UNITED STATES PATENT AND TRADEMARK OFFICE

APPLICATION NO.	FILING DATE	FIRST NAMED INVENTOR	ATTORNEY DOCKET NO.	CONFIRMATION NO.
10/091,854	03/06/2002	William E. Blaha	439	8593

Office Action Summary

DETAILED ACTION

EXAMINER'S ATTACHMENT 1

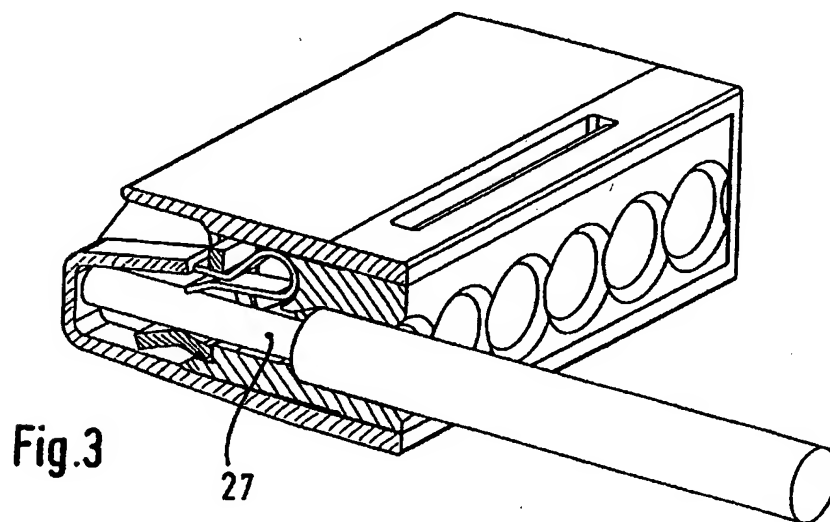
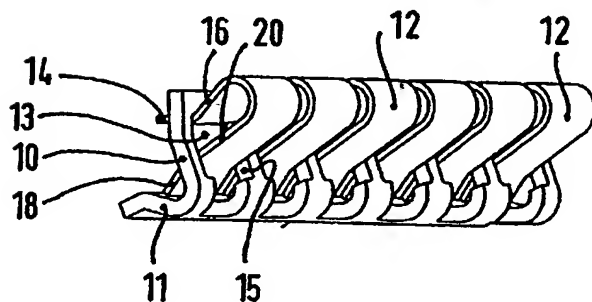
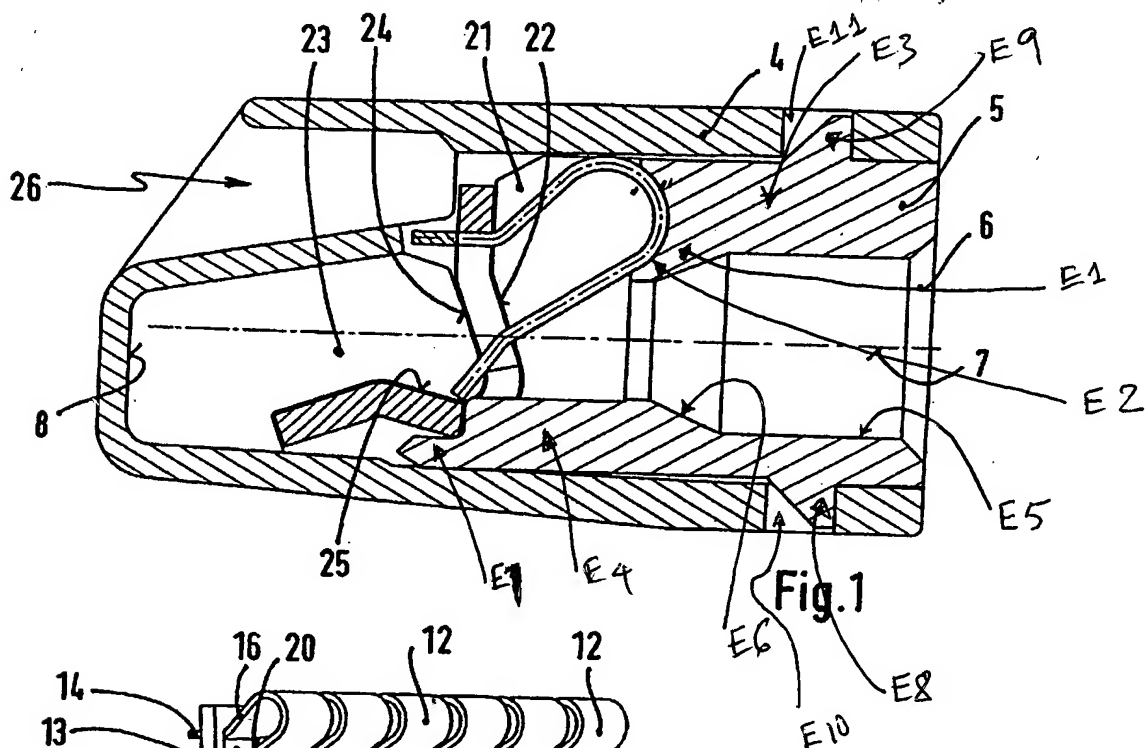
Regarding claims 5 and 17, Hartmann et al. disclose the cap having plurality of retainer lugs (E1, see examiner's attachment 1) and a first edge of the busbar engaging the lug to retain the first edge in a fixed position in the housing (see Figures 1 and 3).

Regarding claim 7, Hartmann et al. disclose the cap has a front portion (E3, see Examiner's attachment 1) and a telescoping portion (E4, see Examiner's attachment 1), the telescoping portion fitting inside the case.

Regarding claim 8, Hartmann et al. disclose the entry ports formed in the front block comprises a cylindrical saddle portion (E5, see Examiner's attachment 1) and a conical guide portion (E6, see Examiner's attachment 1).

Regarding claim 9, Hartmann et al. disclose the front block defining a recess (retainer the lug E1 and the angled edge E2) for receiving the pressure spring.

Regarding claim 10, Hartmann et al. disclose the front block defining an angled wall (E2, see Examiner's attachment).

Regarding claim 20, Hartmann et al disclose a plurality of retention tabs (E8, E9, see Examiner's attachment 1) and a plurality of retention slots (E10, E11, see Examiner's attachment 1) formed in the cap and the case respectively to hold the cap and the case together.

at least one projection (E1, see Examiner's attachment) extending into the enclosure;

EXAMINER'S ATTACHMENT 2

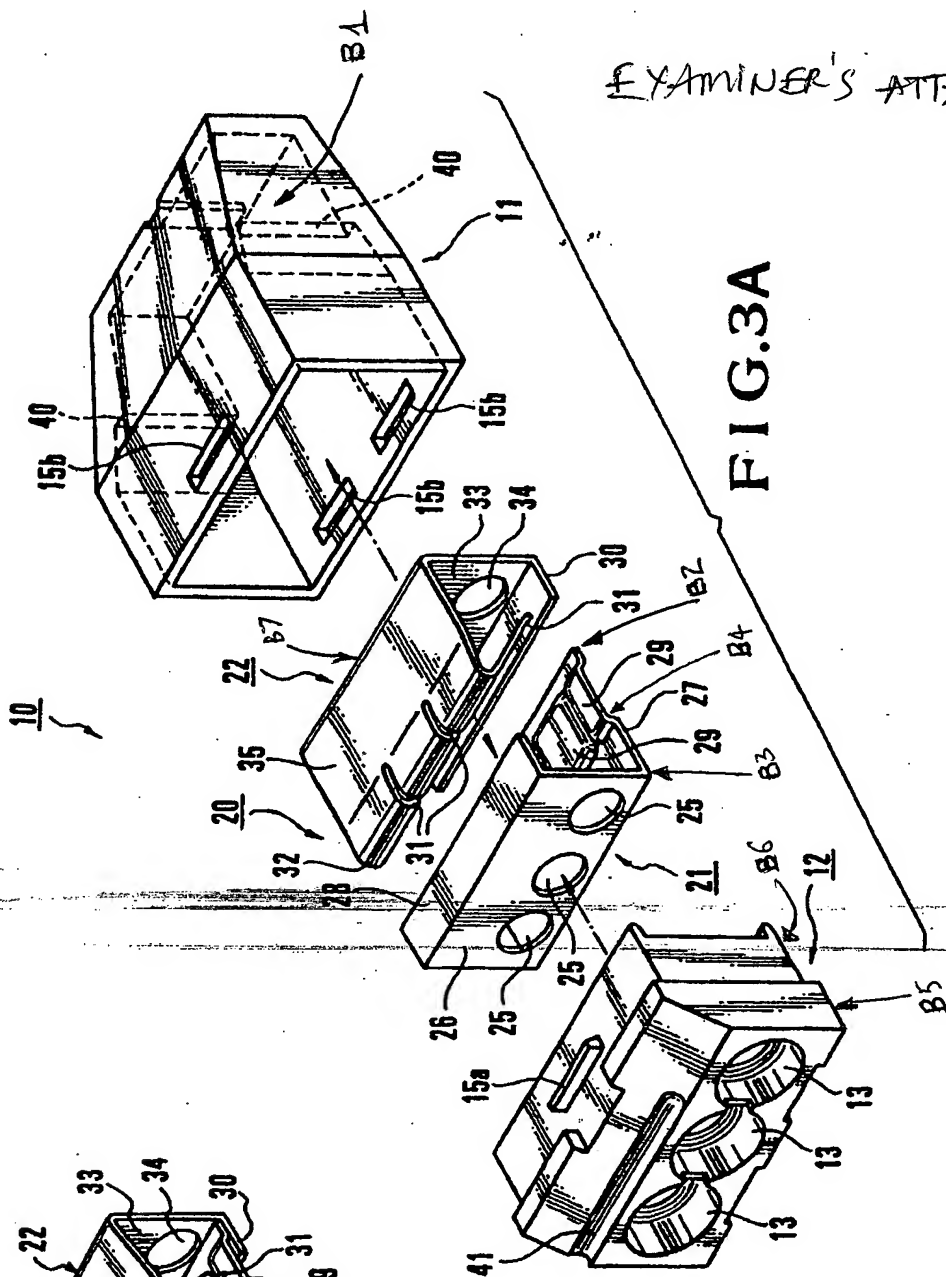
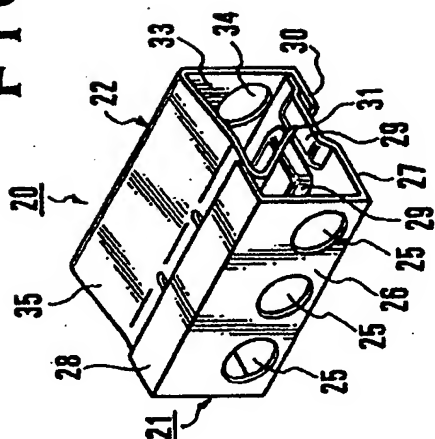
- a conductive bus bar (21) having first and second edge (B2, B3 see Examiner's attachment 2) being supported in the case and the cap respectively.

Regarding claim 14, Tozuka discloses the pressure spring comprising a base plate (35) having a first edge and a second edges (B7, 32 see Examiner's attachment) being supported in the case and the cap respectively (see Figure 1).
